Subject: Comanche Peak Steam Electric Station Independent Assessment Program -
Response to CASE Questions

Reference: (1) Brief Summary of Generic Problems from CASE Witness Jack Doyle,
2/22/84.

Enclosures: Attachment A, Partial Responses to
CASE Questions

FIGURE D2-1

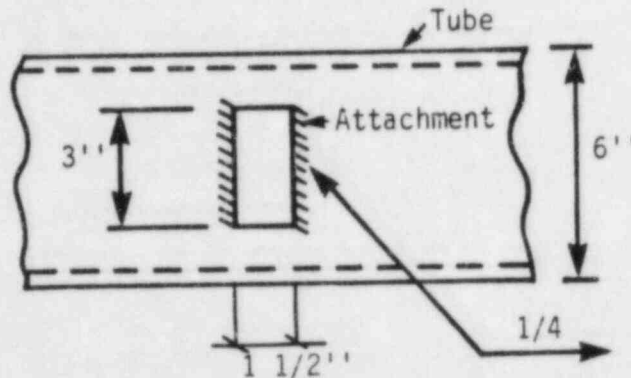
When tube sections are employed in the design of pipe supports, how were the following local effects considered:

- a. Punching shear?
- b. Effect on welds?
- c. Resultant effect due to wall flexibility on moment at tube weld?

- a. Punching shear stresses are within allowable for all supports reviewed by Cygna. This is evidenced by the punching shear check provided in Enclosure D2-1.

Applied axial load = 5092 lbs.

Since the attachment is not a tube and only welded on the 3" side, the calculation of F_a in the following equation for Acting V_p (AWS Section 10.5.1) will be conservatively high, because the loads shared by the 1-1/2" sides of the tube are being neglected.

$$\text{Acting } V_p = 1698$$

$$\begin{aligned} \text{Allowable } V_p &= Q_b Q_f (\text{Basic } V_p) \\ &= (1)(1)(8708 \text{ psi}) = 8708 \text{ psi} \end{aligned}$$

This is considerably greater than the Acting $A_p = 1698$ psi.

Design margin = $1 - (1698/8708) = .80 = 80\%$
